Docket Item #11
BAR CASE # 2008-0102

BAR Meeting
July 30, 2008

ISSUE: Alterations
APPLICANT: Mark Latsios
LOCATION: 712 N. Washington St
ZONE: CDX

Figure 1. Portion of Rear elevation of 712 (left) and 710 (right). Proposed porch to be similar to porch at 710 N. Washington.

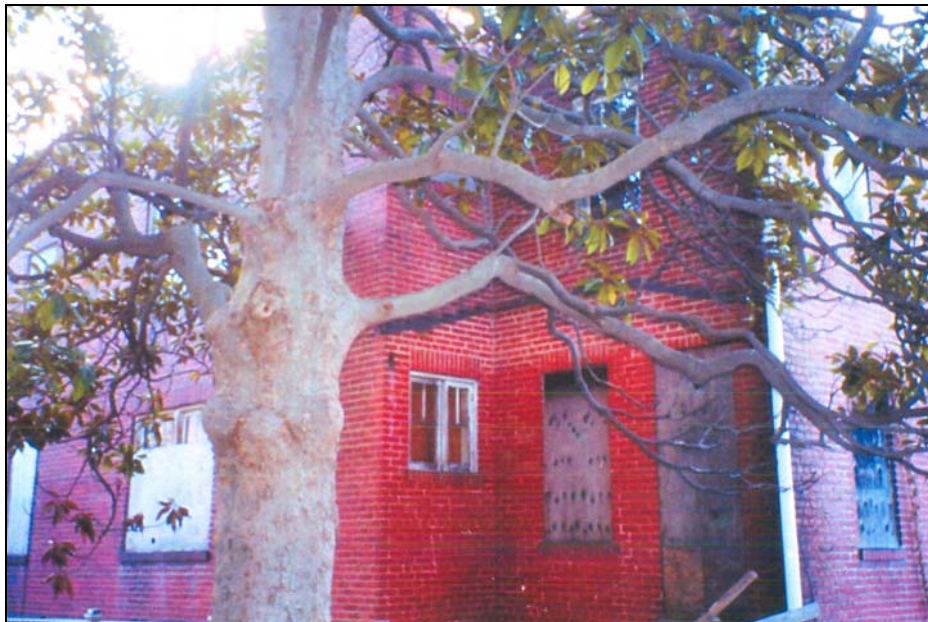
1. That the rear porch ceiling be constructed of solid wood bead board to match as closely as possible the existing bead board ceiling of the front porch;

Figure 3: Elevations of proposed work.

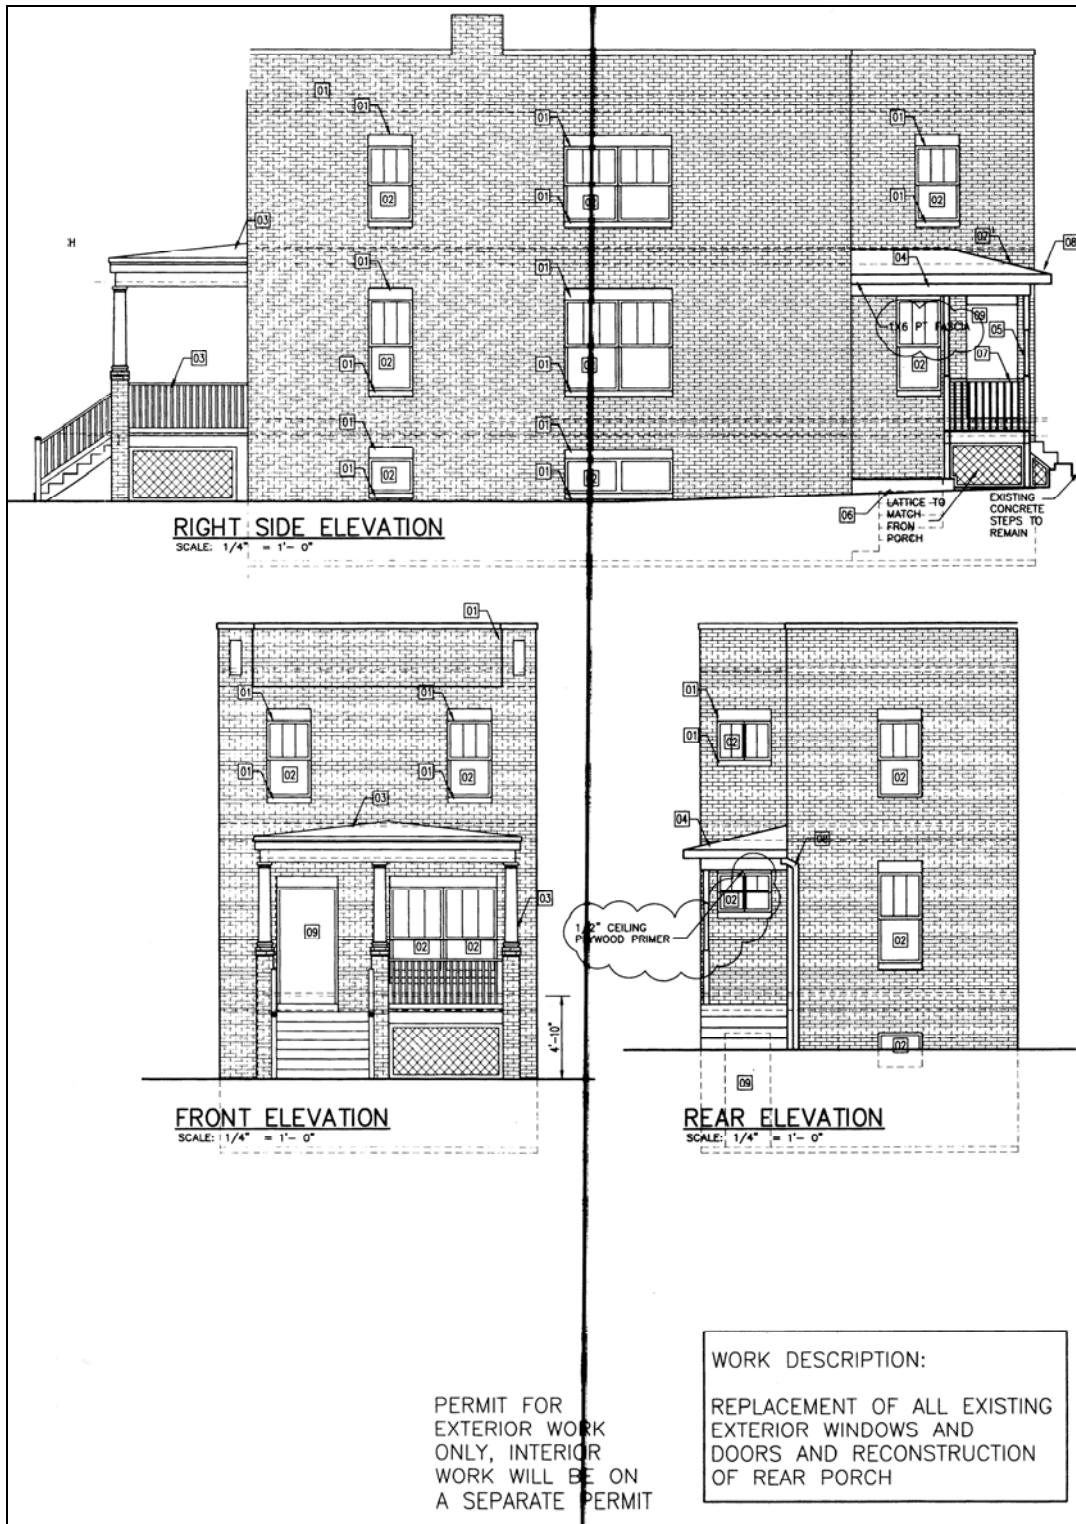
According to the design guidelines, porches are an important architectural element and should be appropriate to the historic style of the structure. Considering that the porch proposed for 712 is a reconstruction of an original historic element of the building, Staff feels that it would not only be appropriate but an improvement upon the existing building to reconstruct the rear porch in this notch in the building along the west and north elevations. In addition, due to the fact that the twin structure at 710 North Washington has retained its historic porch and construction proposed for 712 will be a match in-kind with this structure, Staff feels that all materials proposed are accurate replacements of the original. However, Staff is recommending that the rear porch ceiling be constructed of solid wood bead board similar to the existing front porch ceiling rather than plywood, as proposed, since it is likely that the plywood ceiling in the rear porch at 712 that is being copied is not original.

2. That the applicant repair and retain the historic basement windows that remain;
3. That the applicant be allowed to replace the first and second floor windows with appropriate all wood, single glaze, true-divided light replacement windows that exactly mimic the glazing pattern of the original windows that were removed and exhibit a multi-light vertical muntin divided upper sash and a single light lower sash, with specification sheets to be submitted and approved by Staff prior to purchase and installation;

4. That the applicant reconstruct the surrounding window frame casing to match the original framing that was removed and that remains at the matching twin building at 710 N Washington Street;
